MEMORANDUM

TO: Parks and Recreation Board

SUBJECT: Construction of nine additional floating boat slips, at 2219 Westlake Drive.
File # - Exempt from Site Plan requirements.

MEMORANDUM

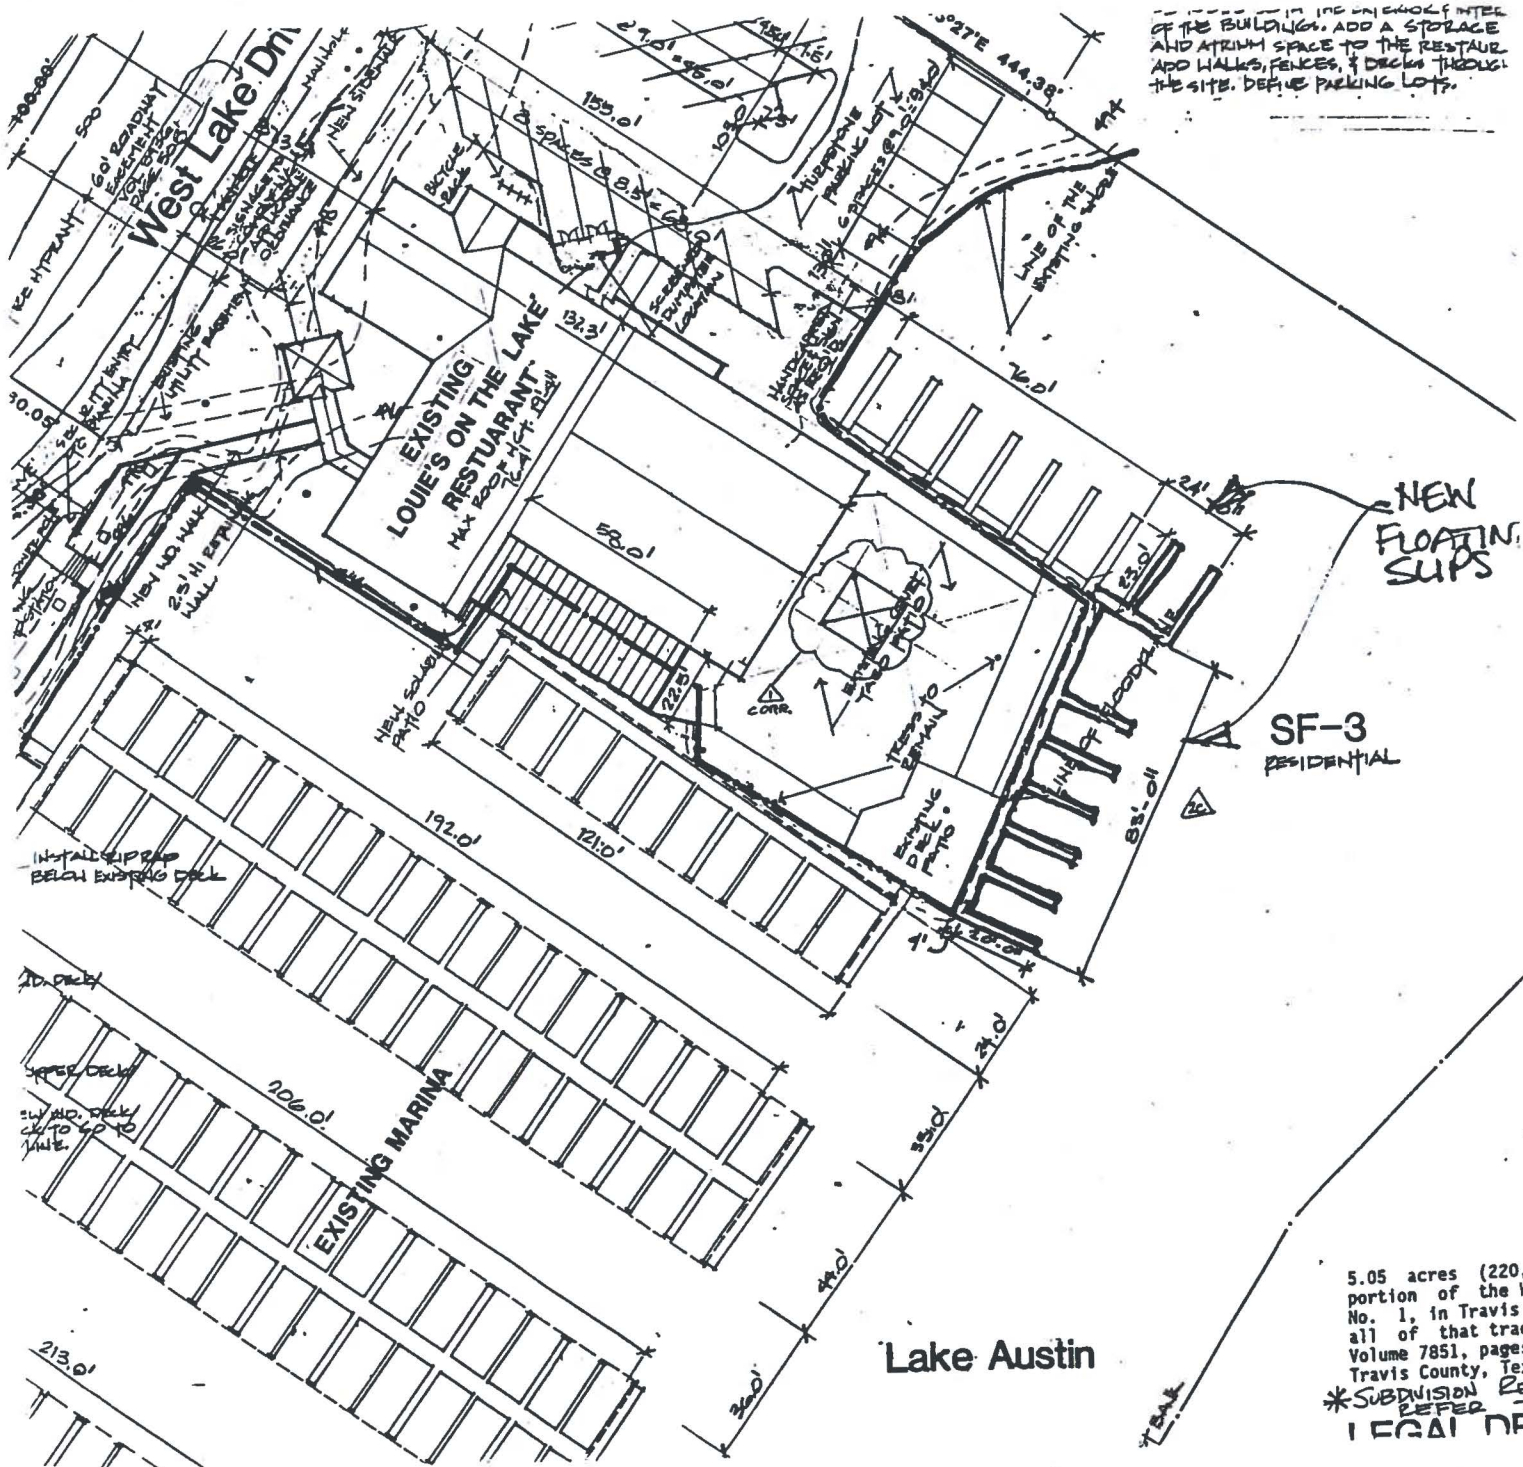
9 floating
slips - Kf
5.13.92

PROVIDE THE SEPARATION BETWEEN KITCHEN & REST OF YACHT CLUB & REST. SPACES.

FRONT & SIDE ELEVATION / SAME DESIGN
 SCALE 1/4" = 1'-0"

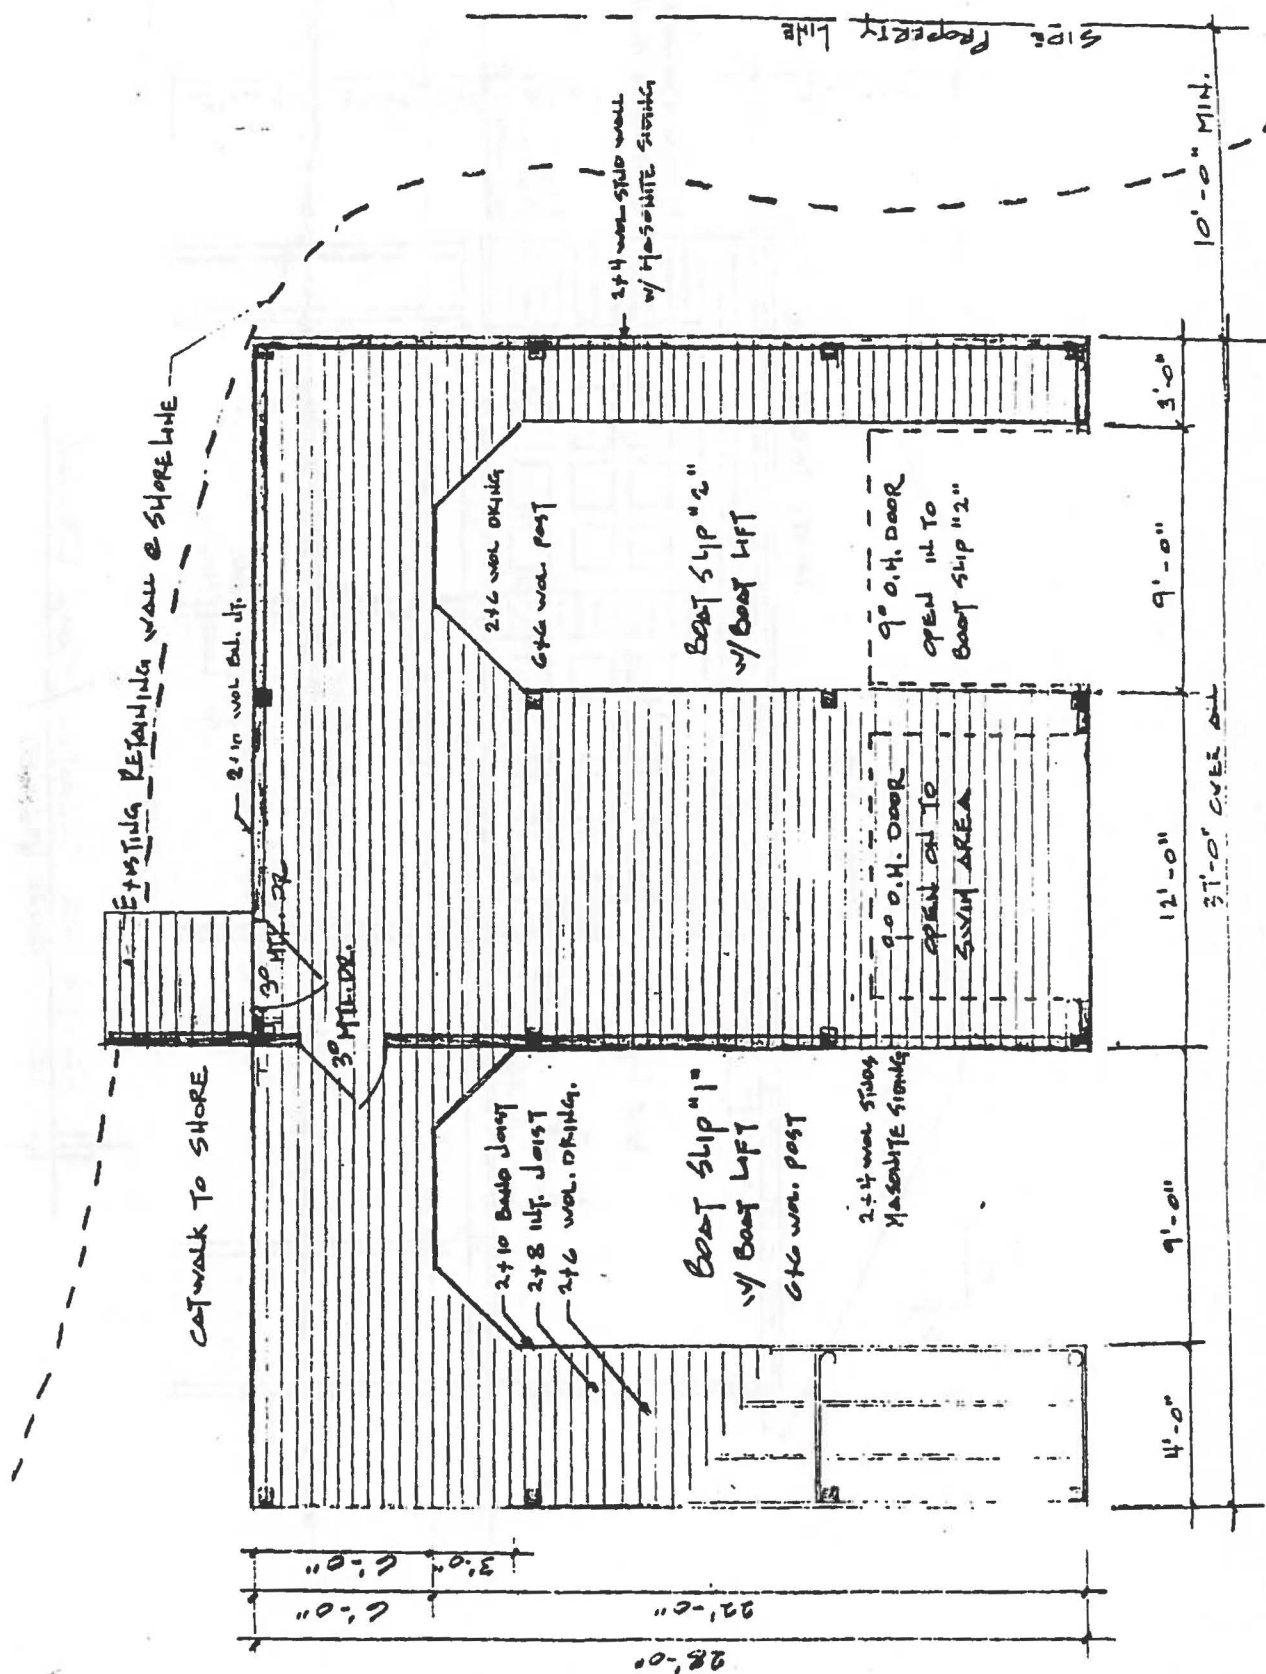
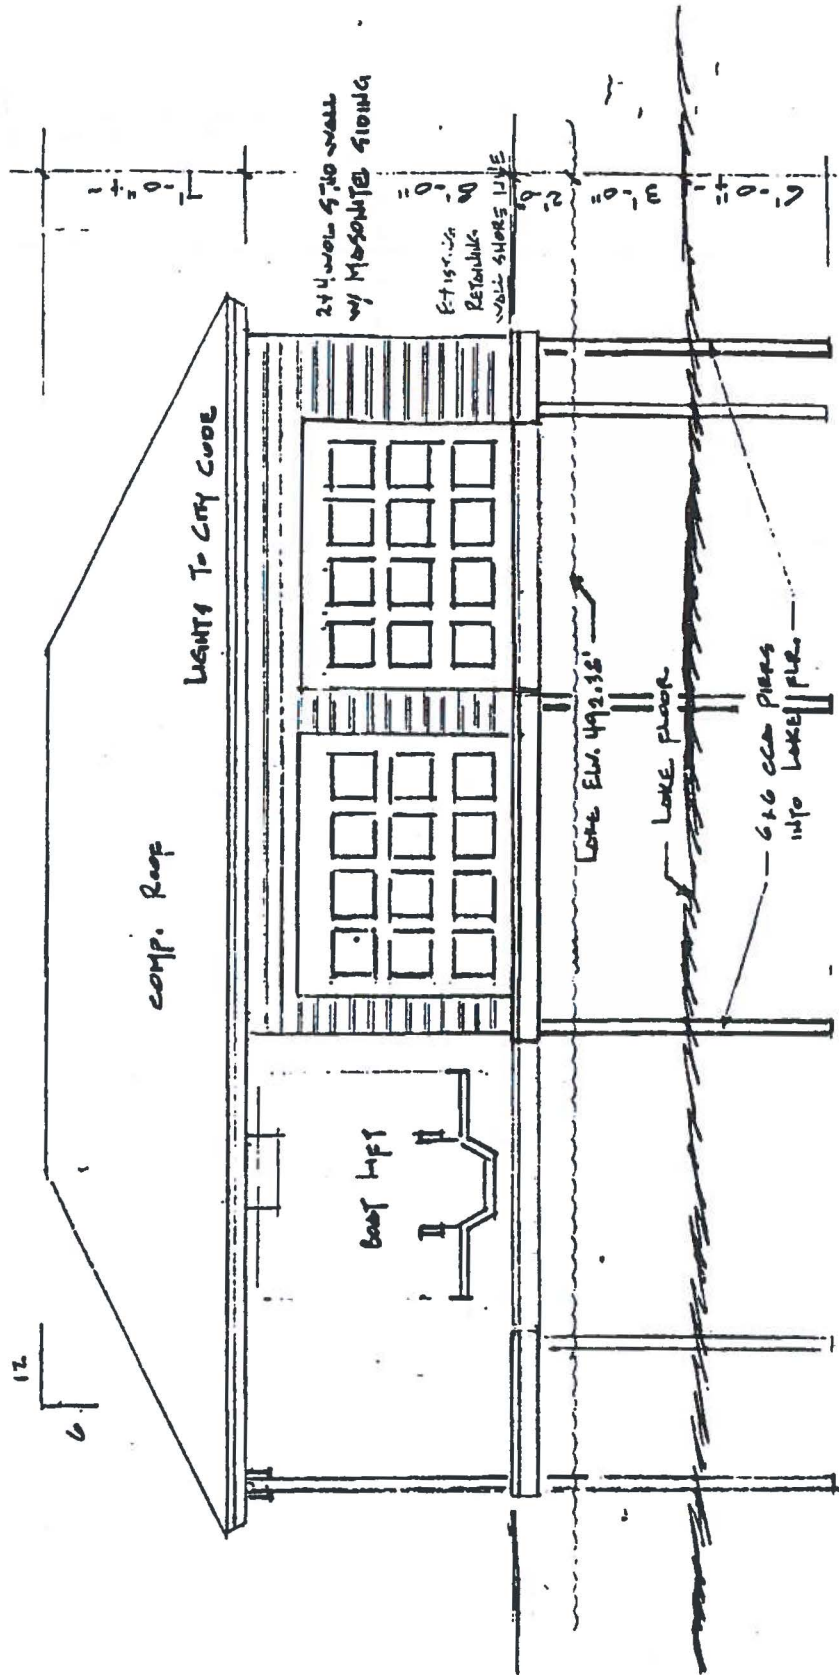
REVISIONS: Change Boat Slip #2 from Eighteen Feet in width
to Nine Feet in width.
Add 2 X 4 Wol. Stud Walls with Masonite Siding.
Add Two Garage type Doors & Two Mtl. passage Doors.
